RESPONSE TO IPC QUESTIONS

Glendell Continued Operations Project

Project Director: David Holmes
Project Manager: Bridie McWhirter
Report No. 4166/R31
Date: March 2022

Figure 3.3 Predicted annual average PM_{10} concentrations due to the Project only (extracted from Appendix 13 of the EIS)

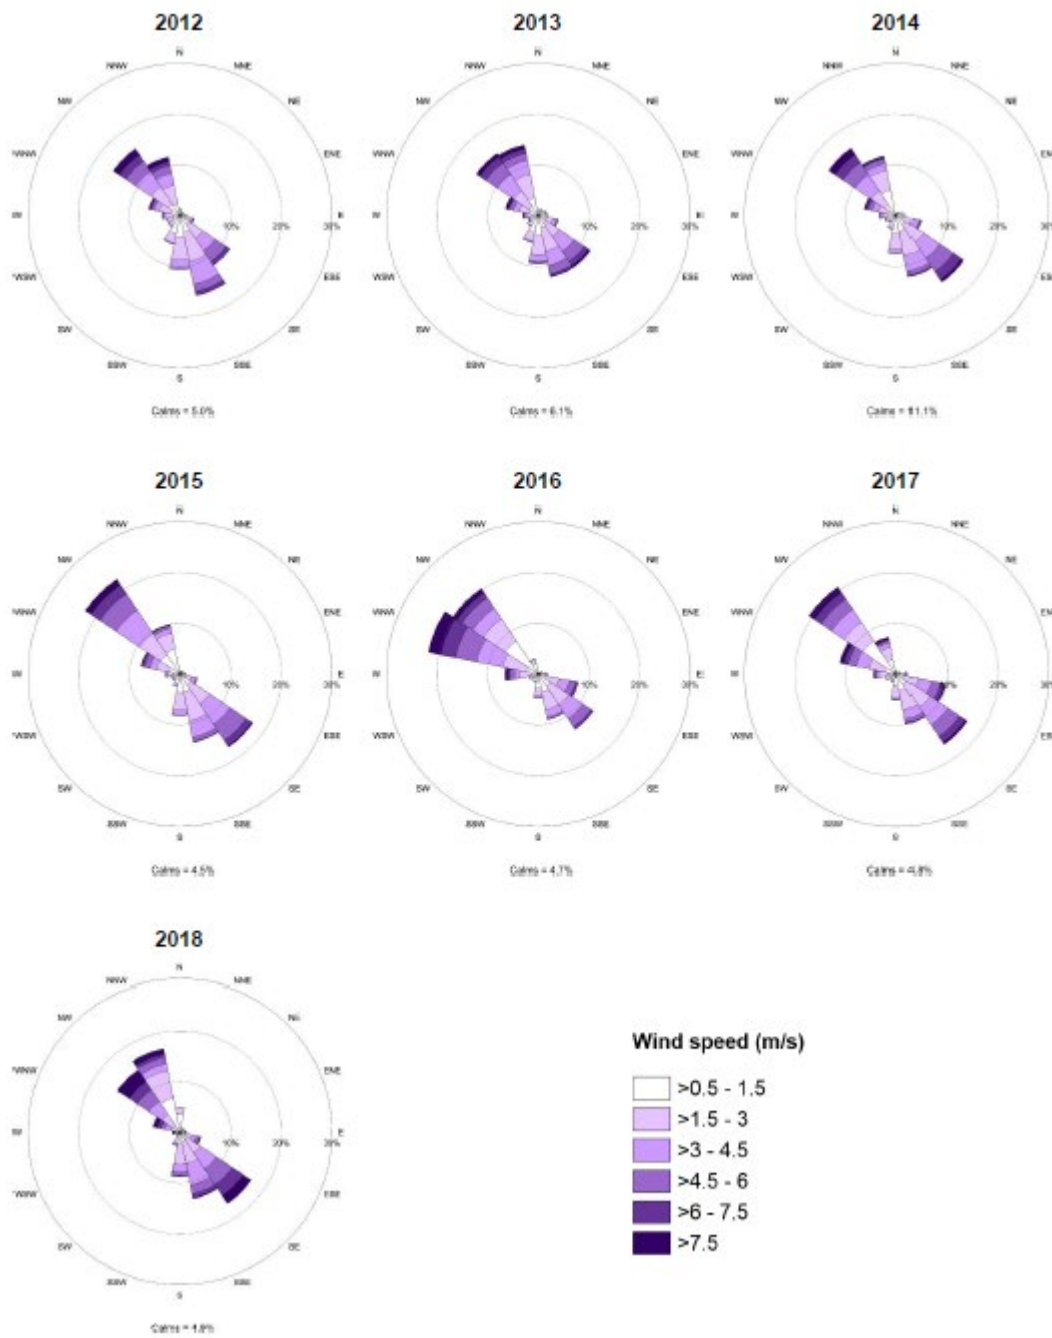
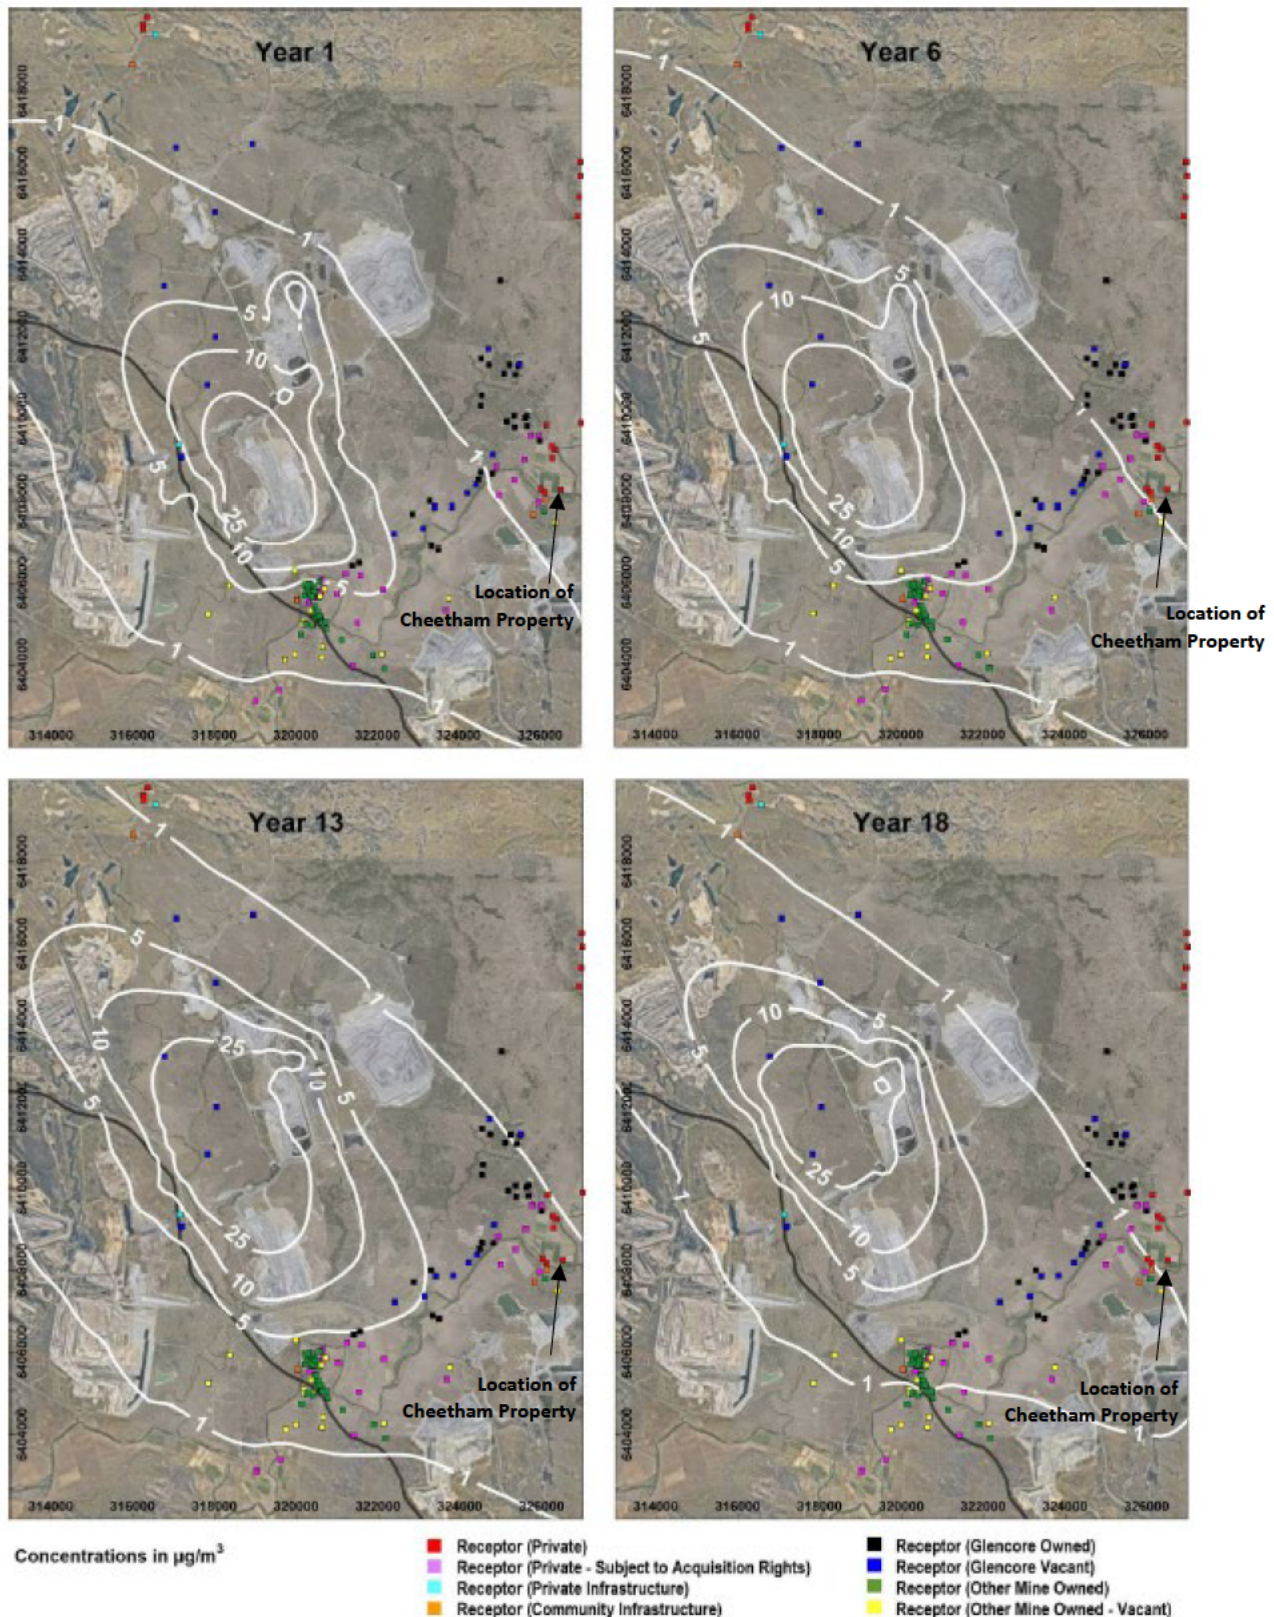
In relation to Graeme Cheetham's submission, please clarify dust impacts at his residence in Middle Falbrook due to terrain and proposed increased dump height due to the Glendell Pit Extension

Meteorological conditions are important for determining the direction and rate at which emissions from a source will disperse. Figure 3.2 shows the annual wind patterns for each year from 2012 to 2018. It can be seen from these windroses that the most common winds in the area are from the south-southeast, southeast, northwest and north-northwest aligned to seasonal variance. This pattern of winds is common for many parts of the Hunter Valley and reflects the northwest-southeast alignment of the valley.
